1A2 KEY TELEPHONE SYSTEM
597- AND 598-TYPE PANELS

1.001 This addendum supplements Section 518-215-417, Issue 5. Place these pink sheets ahead of Page 1 of this section.

1.002 This addendum is issued to add information on the following KTUs:

TABLE A

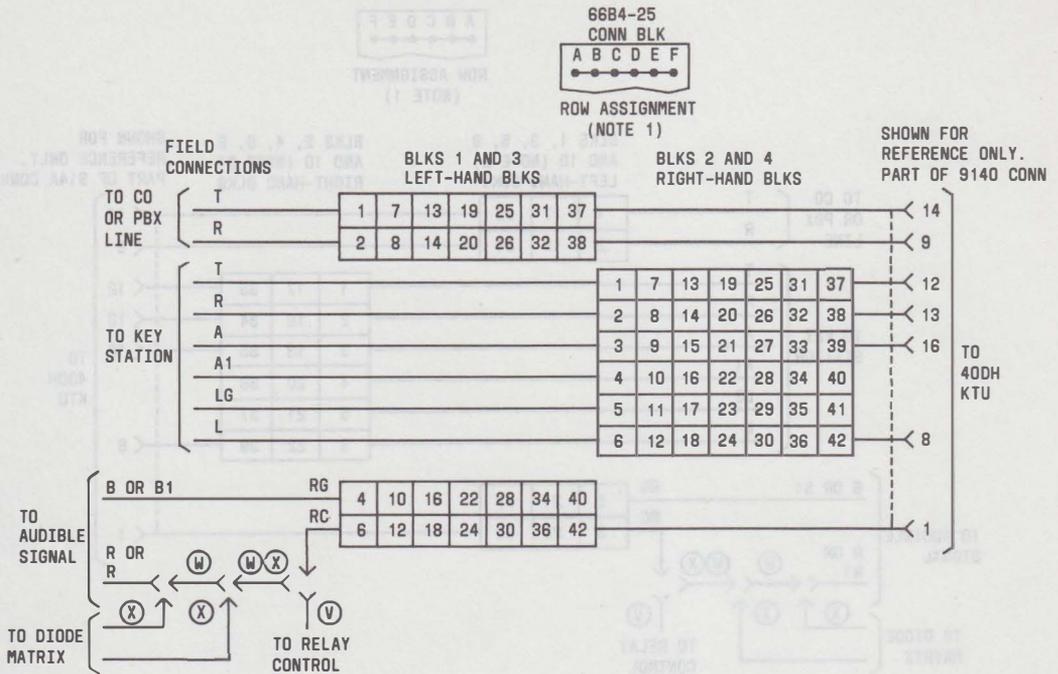
2.001 On Page 4, Table A is revised to show the addition of the 400H and 498A KTUs. A revised Table A is shown in this addendum.

Fig. 10.1—Nondedicated Lead Connections for 400H KTU (CO or PBX Line Circuit) in 597-Type Panel

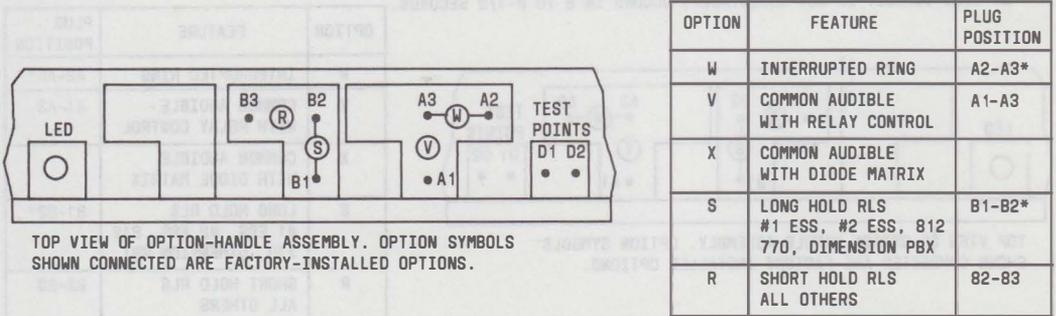
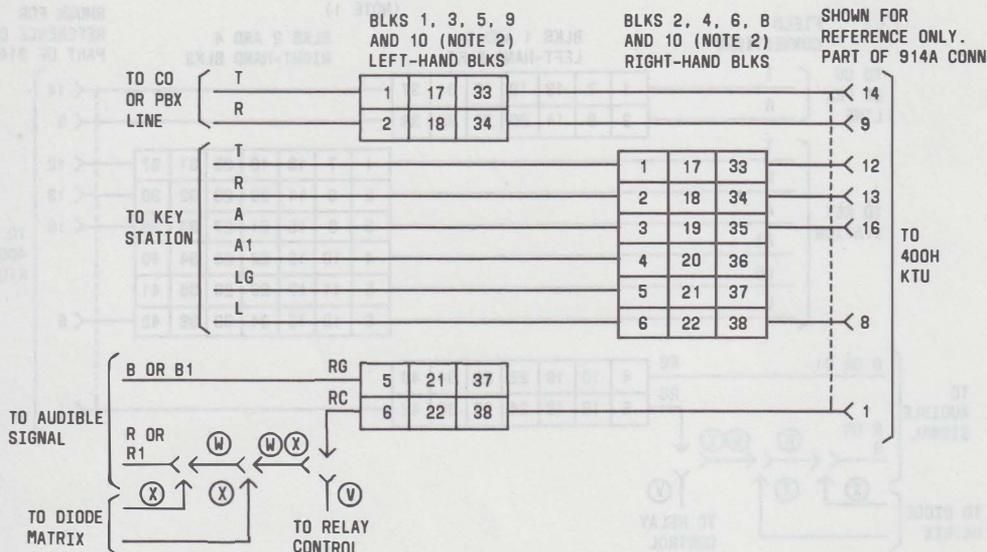
Fig. 10.1—400H KTU (CO or PBX Line Circuit)

2.005 On Page 15, add Fig. 10.1.

Fig. 49.1—Nondedicated Lead Connections for 498A KTU (Music-On-Hold) in 598-Type Panel

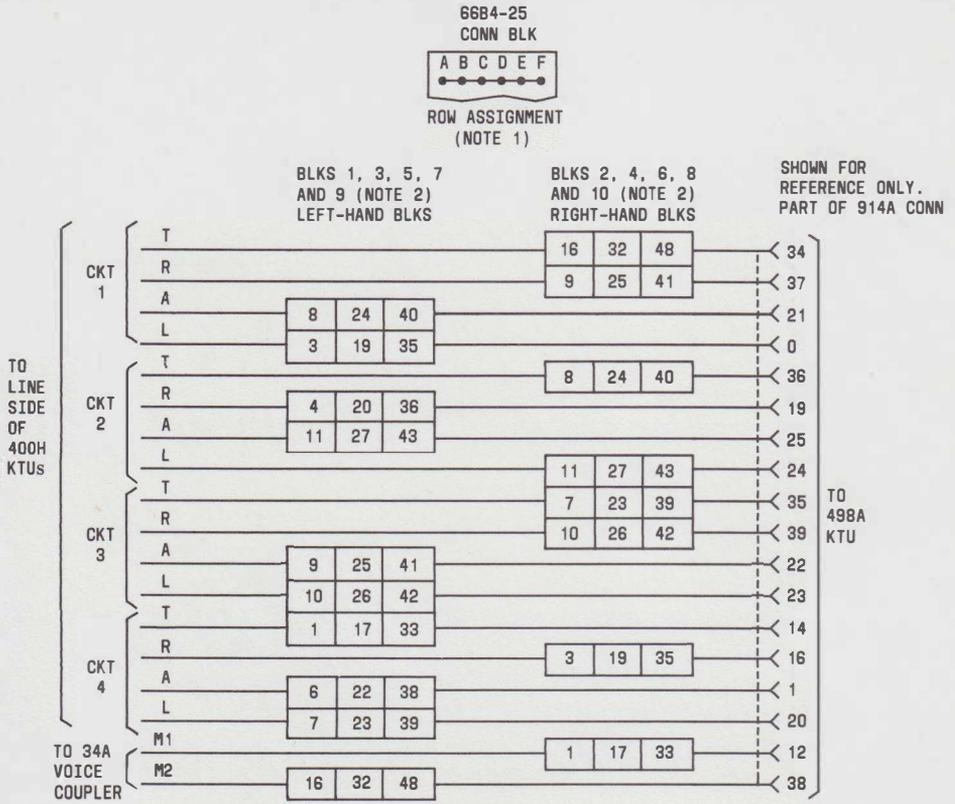
Fig. 49.1—498A KTU (Music-On-Hold)

4.03 The 498A KTU should be used for four circuits only. The 116A1 circuit module should not be added to this unit because of wiring incompatibility in the 598-type panel.

2.007 On Page 54, add Fig. 49.1.
